ADDENDUM

CASE NUMBER: SUP 11-213

REQUEST: Dog Daycare

RE: OPD FILE: #SUP 11-213

Exhibit A

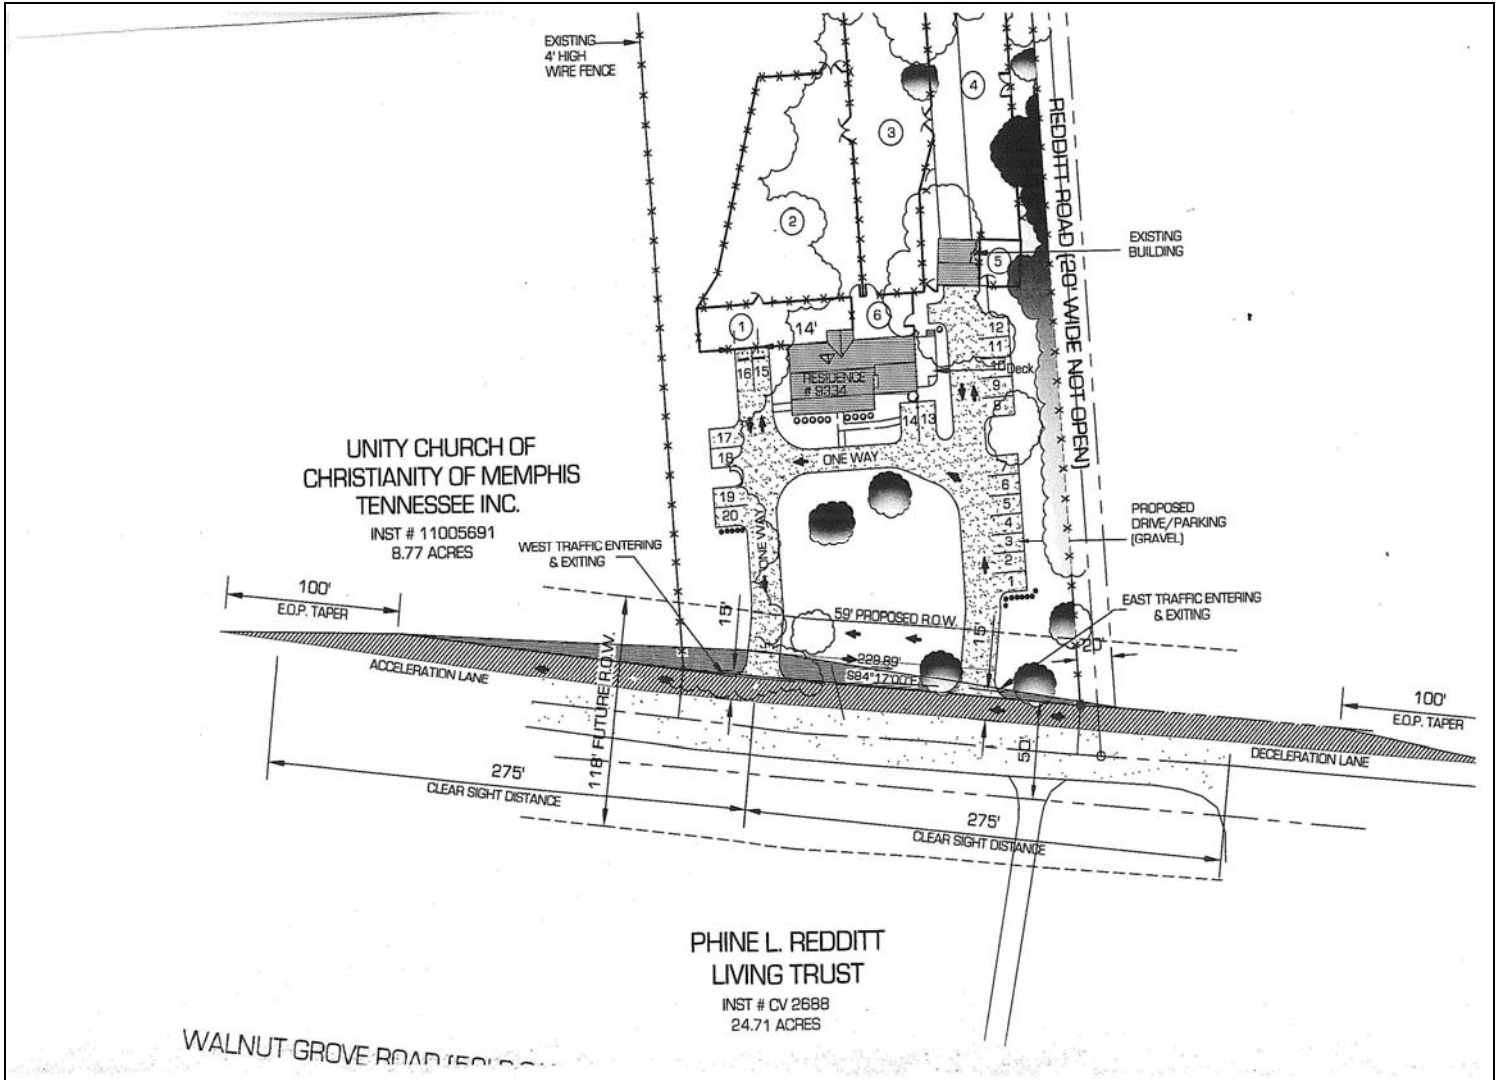
The Exhibit A design illustrates a possible acceleration/deceleration lane. The lane width is up to 12' wide with the stop distance incorporated for a 40 mph speed limit. Pavement edges are to taper into the edge of the pavement with the clear sight distance to accommodate a Major Road (Walnut Grove). Traffic flow on-site will be one way traffic with the entrance driveway on the east side of the frontage and exit driveway to the west side of the frontage. However, everyone is aware of the expense of grading and designing an extra traffic lane for entrance and exit driveways so this leads me to design an alternative.

I must emphasize that of the two scenarios, Exhibit A will be much more costly. Ultimately the City of Memphis Traffic Engineer will need to collaborate with the Office of Planning and Development for an effective solution.

Exhibit B

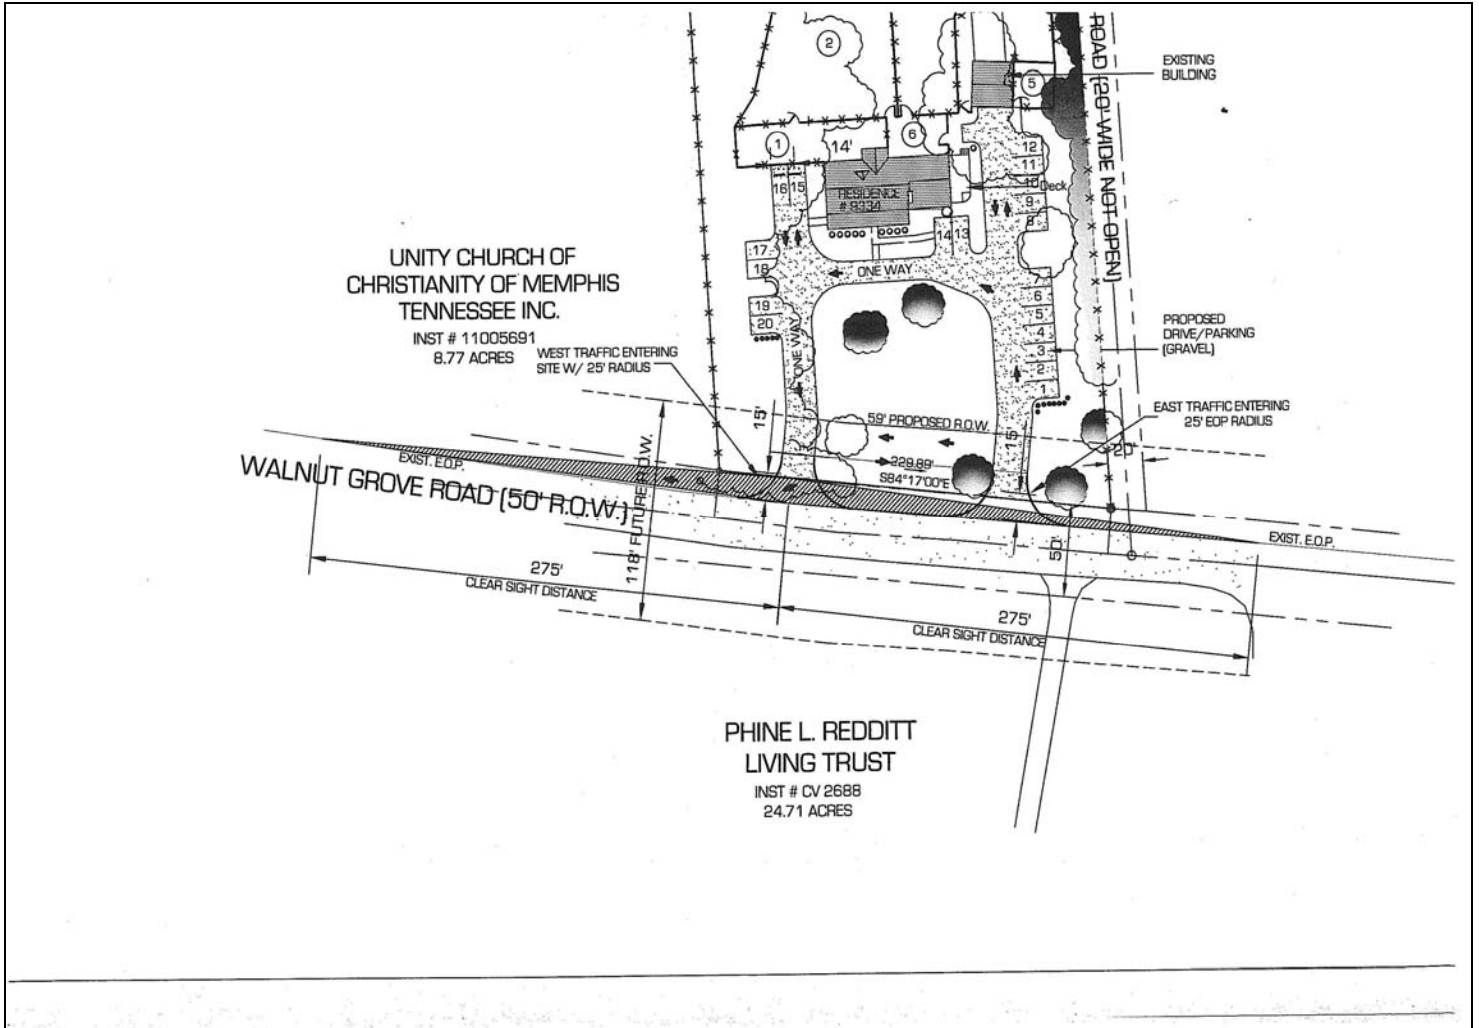
Exhibit B illustrates one-way traffic circulation as Exhibit A without the acceleration-deceleration lane but with larger radii where the driveways terminate onto Walnut Grove Road pavement edges. I noticed that this seems to be what other commercial sites in the area have done. The exhibit also incorporates clear sight distances. Traffic signs shall designate the direction of traffic flow on-site.
